Technical Note

Project: The Eagle at Barrow, Clitheroe

Subject: LLFA Objection Response

Client:	Fence Gate Limited		
Project No:	08336	Version:	A
Document Ref:	08336-TN-02	Author:	Andrea Nelmes
Date:	10/07/2026	Approved:	Alison Caldwell

Figure 1: Excerpt from Indicative Foul & Surface Water Layout Dwg No. 08336-WR-0500

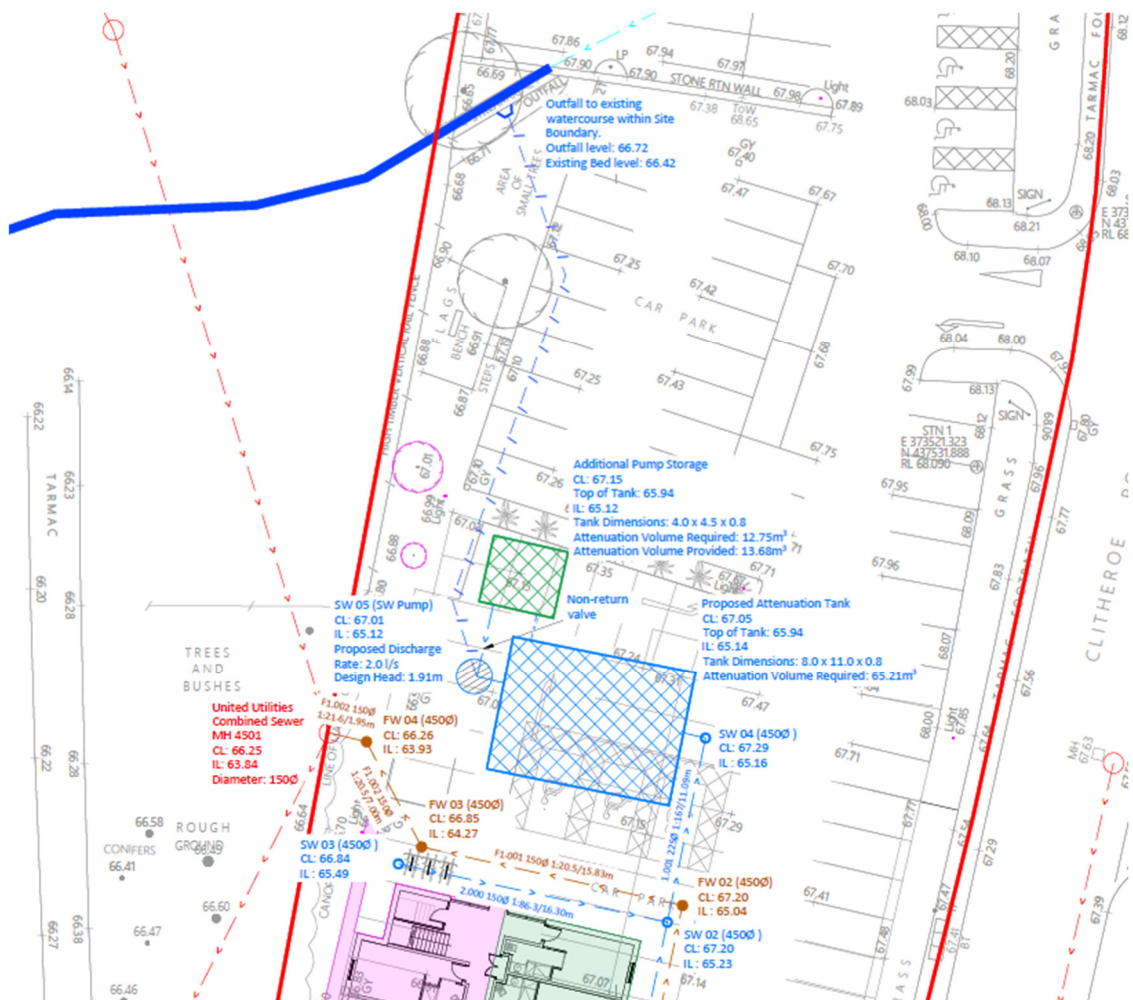
- 2.2.1 The LLFA has objected to the proposed surface water drainage strategy on the basis that insufficient evidence has been provided to demonstrate why pumping is required to drain the Site, in accordance with Standard S12 of the *Defra Non Statutory Technical Standards for Sustainable Drainage Systems*. Specifically, the LLFA considers that the submitted information does not adequately demonstrate why drainage by gravity is not reasonably practicable.

1. **Provide evidence to demonstrate why pumping is required** to drain the development site in line with Standard S12 of the Defra Technical Standards for Sustainable Drainage Systems.

Standard S12 of the Defra Technical Standards for Sustainable Drainage Systems requires that pumping should only be used to facilitate drainage for those parts of the site where it is not reasonably practicable to drain water by gravity. The applicant has not provided robust evidence as to why pumping is required to drain the development site, nor provided evidence as to why the proposed drainage system cannot be drained by gravity. This is sufficient reason in itself for a refusal of planning permission.

2.3.3 In accordance with Standard 1, the proposed drainage strategy discharges attenuated surface water runoff to the adjacent ordinary watercourse (Priority 3) via a pumped rising main, rather than by gravity to the existing 150 mm diameter United Utilities combined sewer (Priority 5), as illustrated on Figure 1 and Appendix B. Accordingly, the proposed strategy achieves a significantly higher priority runoff destination than the only available gravity alternative.

- 2.3.4 The LLFA's reference to Paragraphs 181 and 182 of the National Planning Policy Framework, requiring sustainable drainage systems to have appropriate minimum operational standards, is acknowledged. However, the operational resilience of the proposed pumped drainage system should be considered alongside the alternative gravity discharge to the existing public combined sewer. Whilst the use of pumps introduces a mechanical component requiring ongoing maintenance, the proposed drainage strategy has been designed to ensure that, in the unlikely event of pump failure, surface water can be safely contained on site. In addition to the required attenuation storage of 65.21m³, the system incorporates a further 125m³ of emergency storage, providing a total storage volume of approximately 190m³—almost three times the attenuation volume required. This additional storage provides sufficient resilience to accommodate a temporary pump outage, allowing time for inspection, maintenance and emergency response without resulting in off-site flooding.

- 2.3.5 By comparison, directing surface water runoff by gravity to the existing 150 mm diameter public combined sewer (refer to Appendix C for asset mapping) would unnecessarily introduce additional hydraulic loading to existing combined sewer infrastructure during rainfall events and, during periods of network exceedance, has the potential to increase the frequency and/or volume of Combined Sewer Overflow (CSO) operation together with the associated risk of sewer surcharge.

- 2.3.6 Although such a solution may be physically achievable, it represents the lowest priority runoff destination within Standard 1 of the National SuDS Standards and has the potential to increase the volume and frequency of Combined Sewer Overflows (CSOs) and the risk of sewer surcharge during periods of intense rainfall. Any resulting flooding from the public sewer network would also present a significantly greater environmental and public health risk owing to the potential presence of foul sewage, whereas the consequence of a temporary pump failure would be limited to the controlled storage of clean surface water within the site's designated low point.
